Channel Design Report For 60% Design: Rolling Meadows Channel and Floodplain Modification

Updated: January 31, 2023

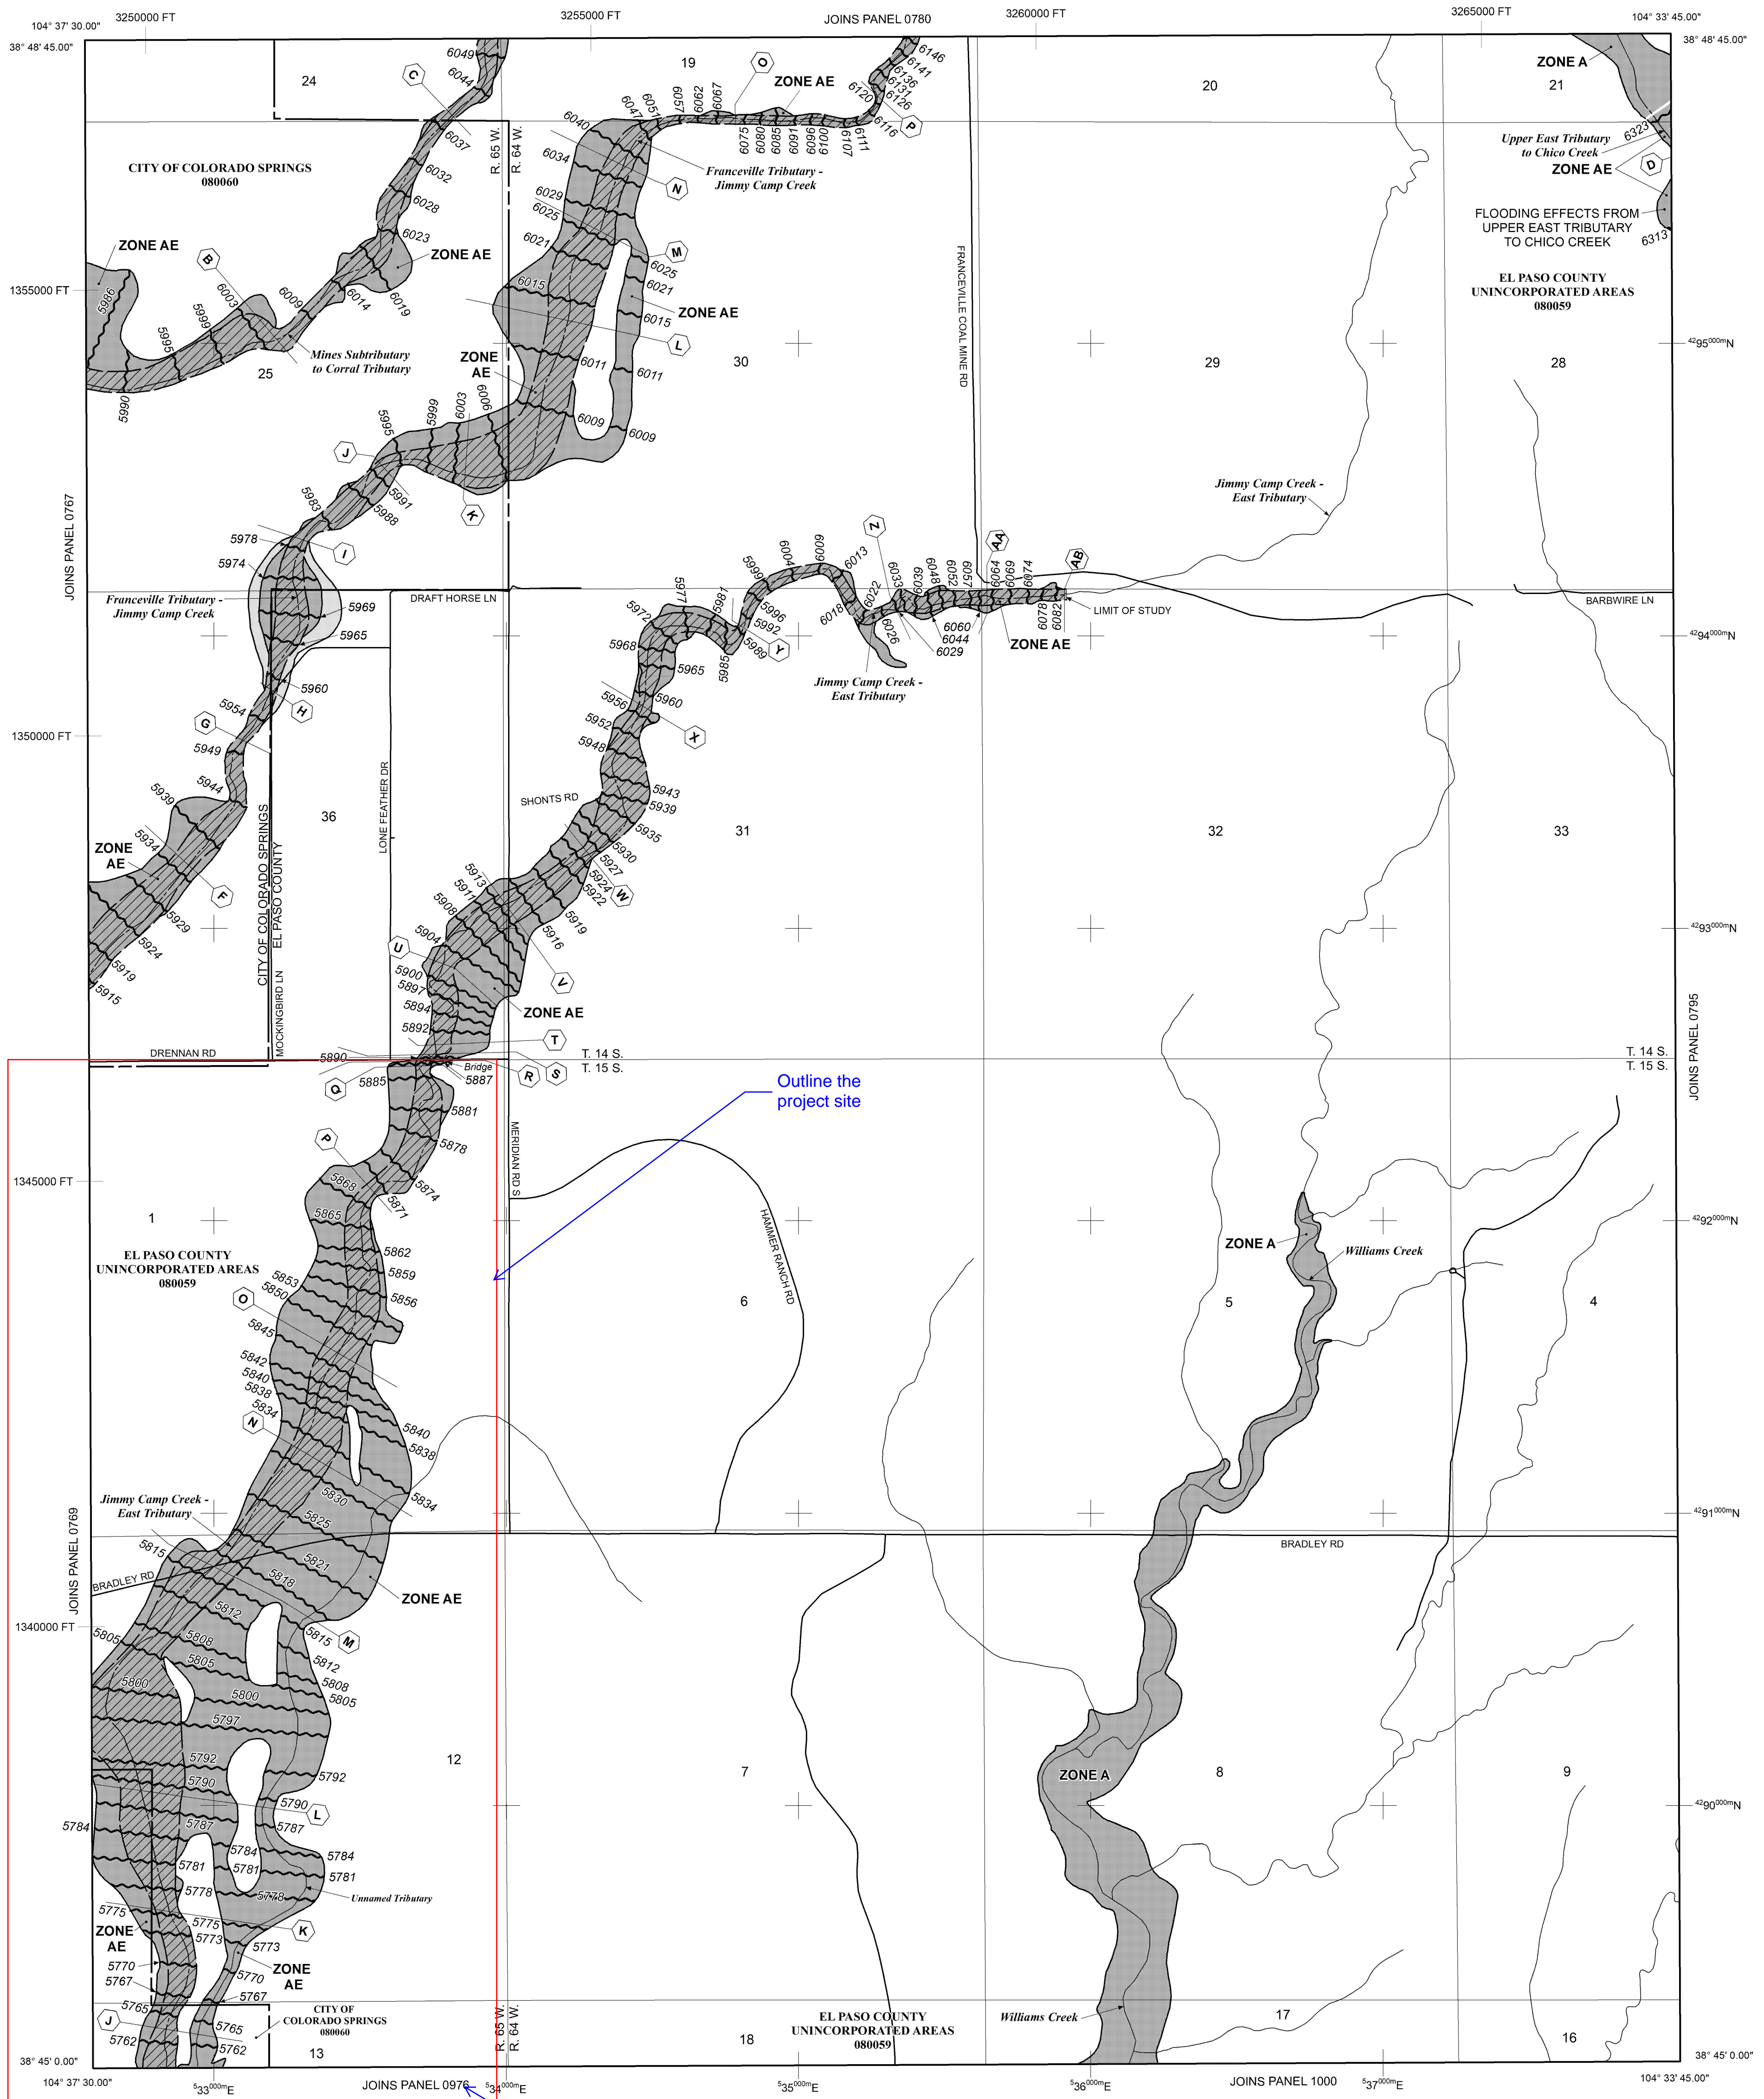
add panel
